| LATEST REVISION'S DISCRIPTION | |

TITLE 52 PIN F/P

DWG NO. IFK52F1-2252BA

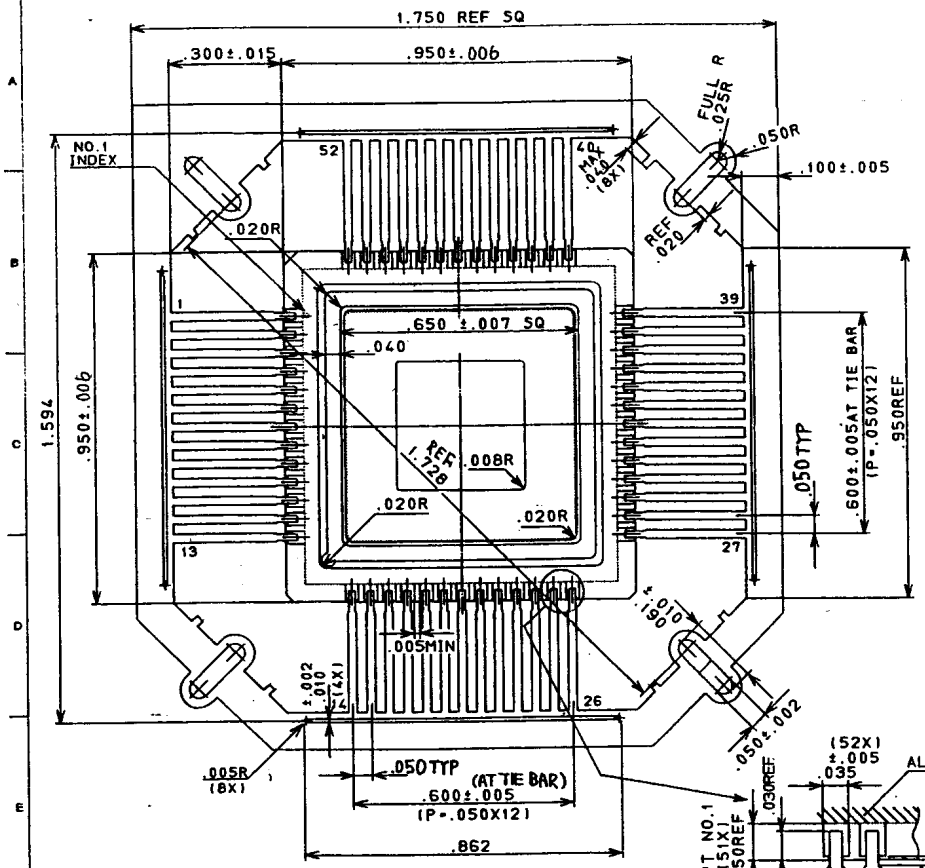
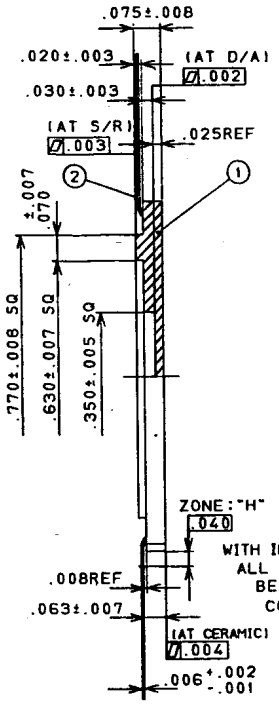
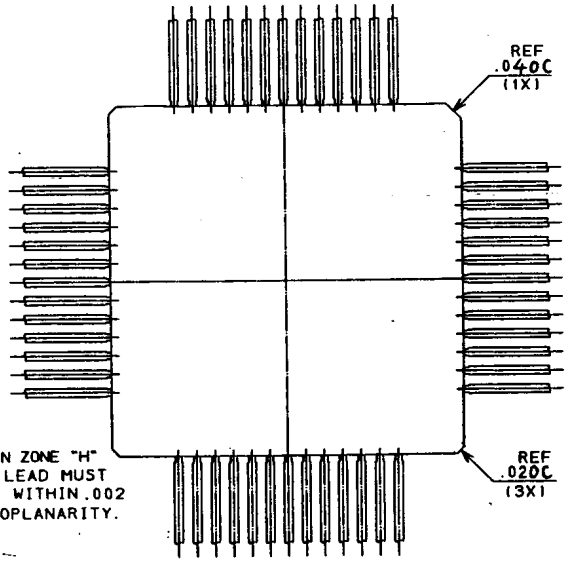
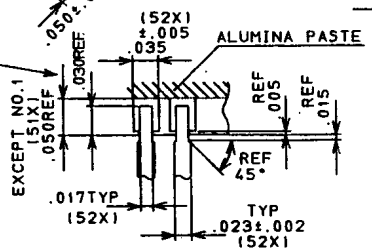
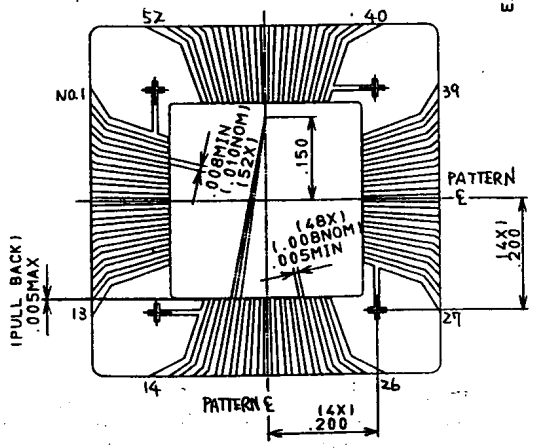
| LATEST REVISION'S DISCRIPTION | |
|---|---|
| C | CHG O.D TOLERANCE 0.950±.010 TO 0.950±.006<br>CHG NTK P/N -2252B TO -2252BA<br>DEL NTK P/N -2252A<br>CHG CUSTOMER THS TO TCS |
